PROJECT: NEW ADMINISTRATIVE BUILDING FOR THE NATIONAL ASSEMBLY OF CAMBODIA

WORK PACKAGE: MAIN CONTRACT WORK

SUBJECT: CLARIFICATION OF BIDDING DOCUMENTS NO.03

CLARIFICATION OF BIDDING DOCUMENTS NO. 03

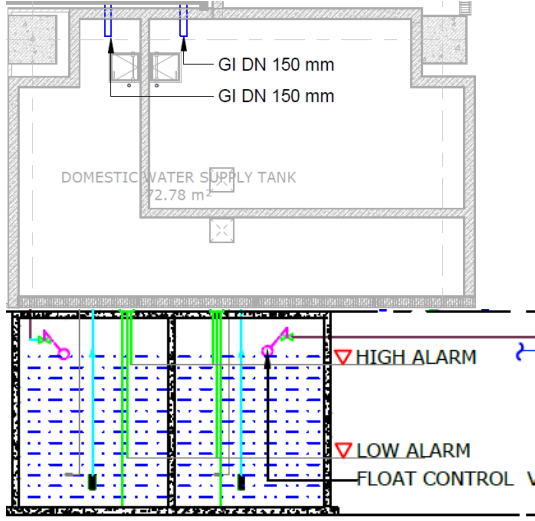
6	<p>In DWG. NA-MV-6002 Lift Lobby Pressurization Fan, Cap. 18200L/S @ 400Pa or 15200L/S @ 400Pa? Please confirm.</p>	<p>For Lift Lobby Pressurization Fan Capacity, please follow the drawing layout and schematic diagram with drawing no. NA-MV-6002 (15200L/S @400MPa)</p>

In DWG. ME-GE-GE-0101 & Bill No.14 Plumbing

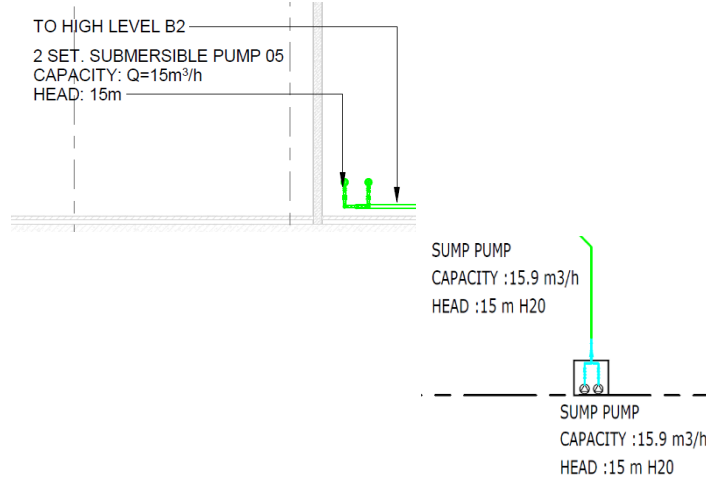
Submersible pump 1 duty-1 standby, flow 15.9 m³/h @15m H₂O c/w other valve and fitting up to header =7set or flow 15.9 m³/h @15m =6set and flow 10l/s @10m =1set? Please confirm the required quantities and flow.

Please follow schematic drawing:

1 duty-1standby
 6 sets =15.9m³/h
 1 set =10l/s

In DWG. ME-NA-WW-1101, ME-NA-WW-6001

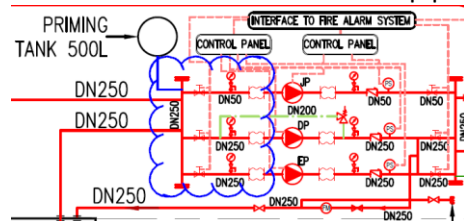
Submersible pump 1 duty-1 standby, flow 15.9 m3/h @15m or flow 15 m3/h @15m? Please clarify the difference of flow.

Please follow schematic design ME-NA-WW-6001. It is 15.9m3/h

In DWG. ME-NA-FF-6001

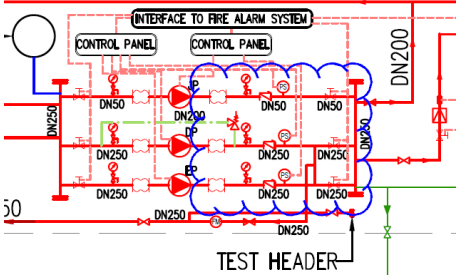
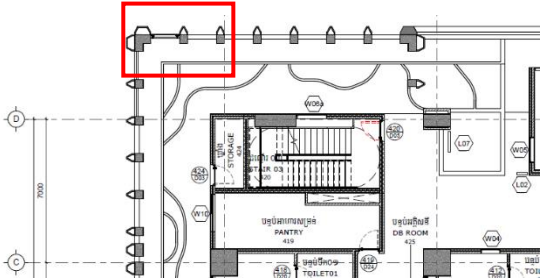
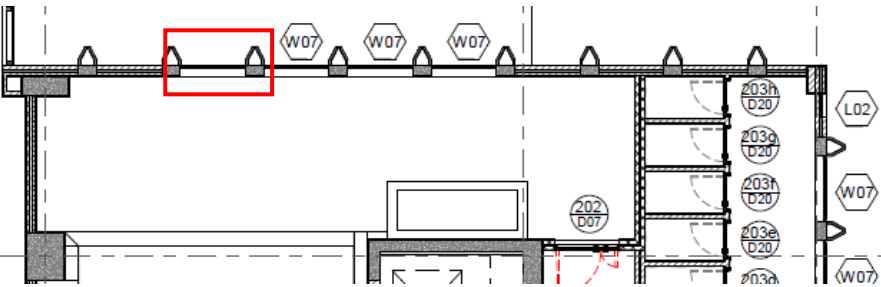
There is no Y-strainer for Suction pipe. Please confirm.

Please provide as shown in drawing no. ME-NA-FF-1102 and ME-NA-FF-5002.

In DWG. NA-AR-1704, NA-AR-1706, NA-AR-1708, NA-AR-1709 and NA-AR-1710

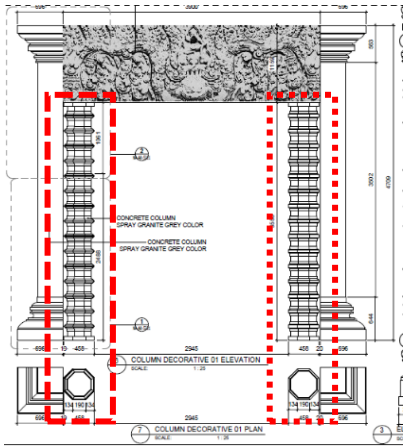
Is there any waterproofing for this area (yellow highlight zone)?

For the waterproofing there will be applied on the terrace, roof top, balcony, landscape, and wet area.

Please refer to downloadable link below for the updated drawing.

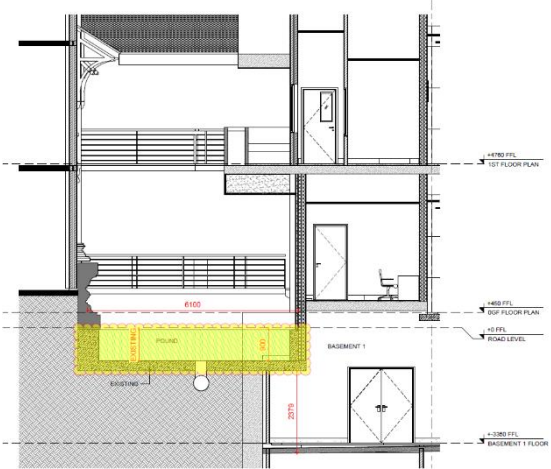
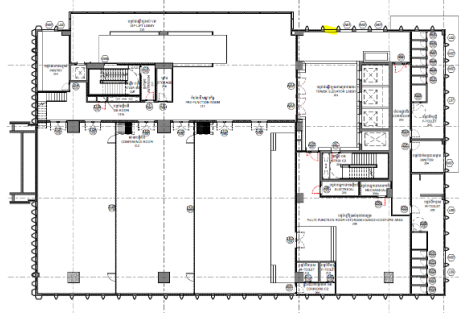
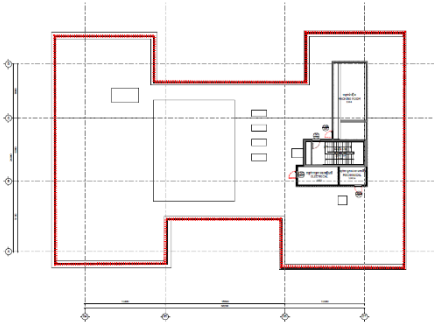
In DWG. NA-AR-5219
 Based on Column Decorative 01 plan & elevation, the left and right columns are not the same decoration. Please clarify and provide details drawings.

For the column decoration will be the same for both sizes.

Please refer to downloadable link below for the updated drawing.
